Appl. No. 09/778,375  
Atty. Docket No. 8414Q  
Amdt. dated January 6, 2004  
Reply to Office Action of October 21, 2003  
Customer No. 27752

#### REMARKS

#### Changes to the Drawings

Fig. 2 52  
redesignated  
54

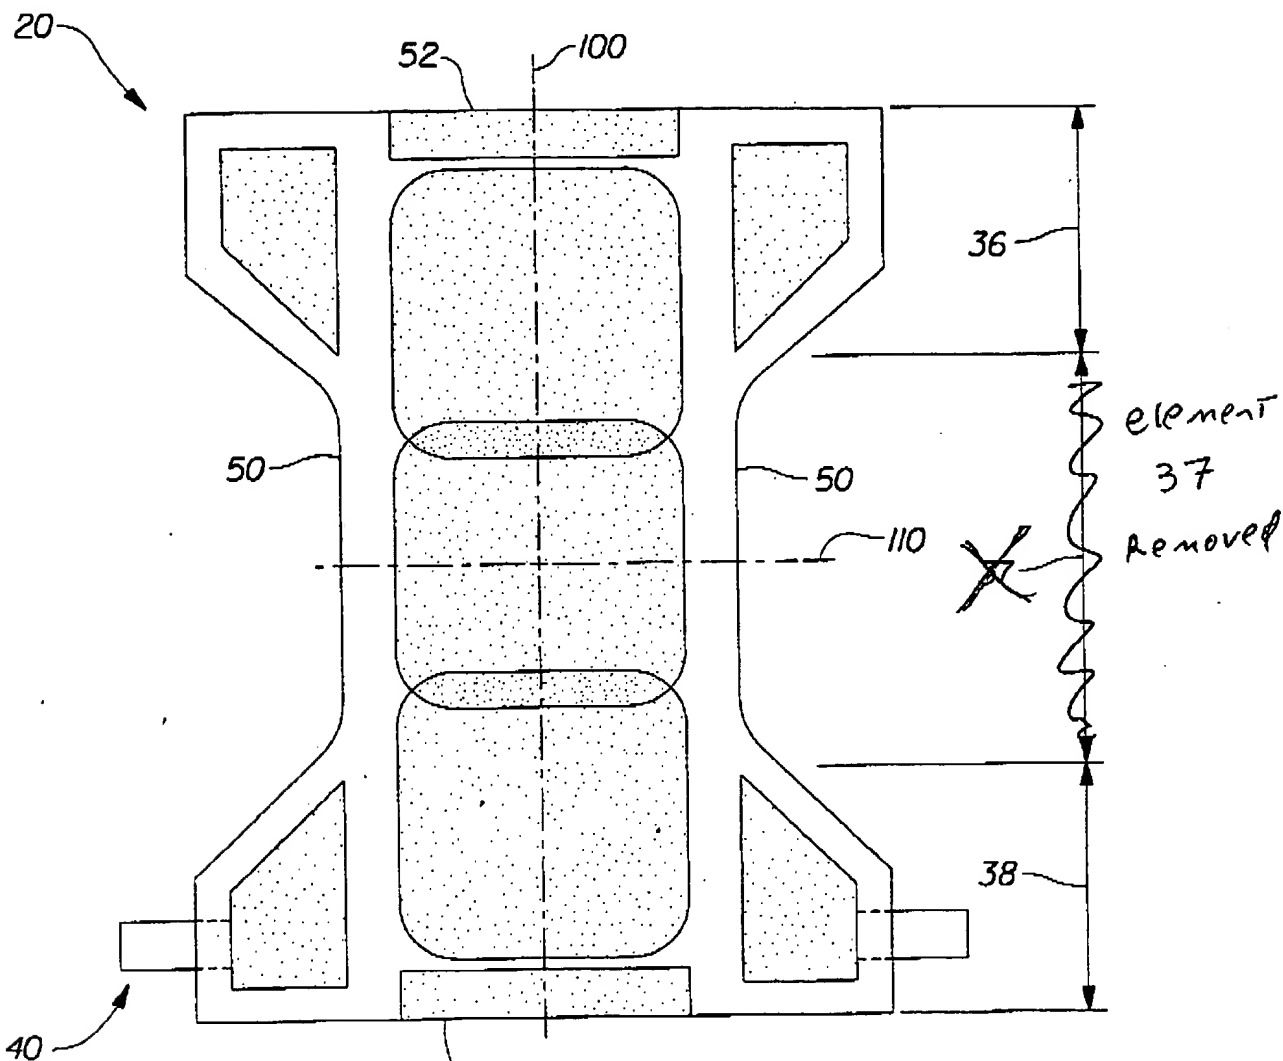
The drawing changes made are to reference numerals and lead lines. Specifically, In Fig. 1, previously omitted reference numeral 56 has been added. In Figs. 1 and 2, reference numeral 52 has been redesignated reference numeral 54. In Fig. 1, reference numerals 37 and 120 have been removed. In Fig. 2, reference numeral 37 has been removed. In Fig. 4, reference numerals 500, 502, 504, 506, 508, 510, 43, and 44 have been removed. In Fig. 5, reference numeral 605 has been removed. The attached appendix provides replacement sheets, and annotated sheets showing the addition and deletions of the above-detailed changes.

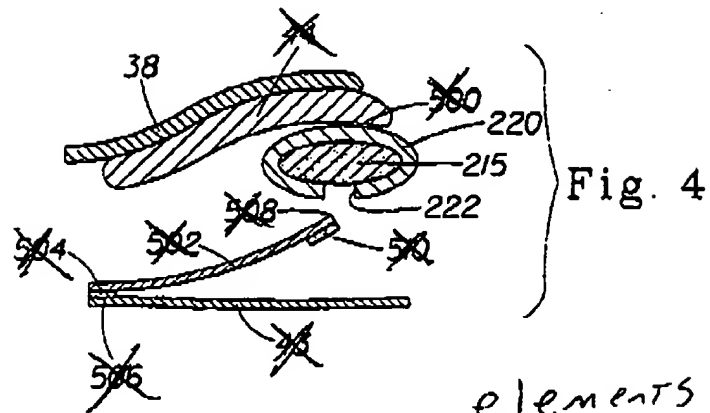
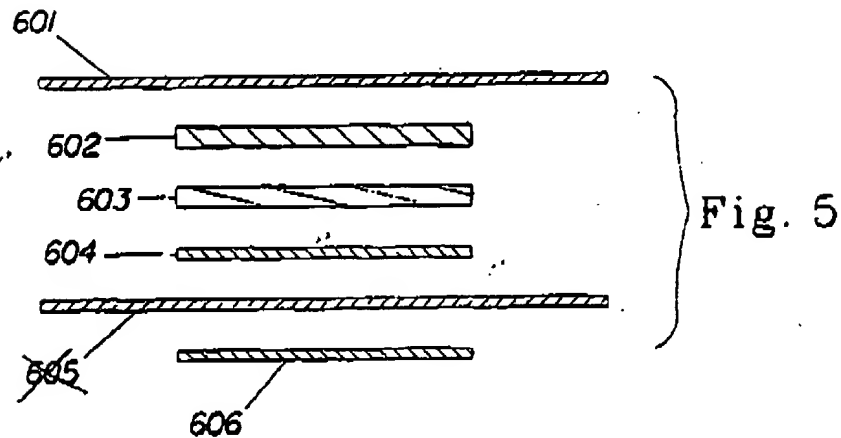
elements  
500, 502, 504, 506, 508,  
510, 43 and 44  
have been removed

Element 605 has been  
removed
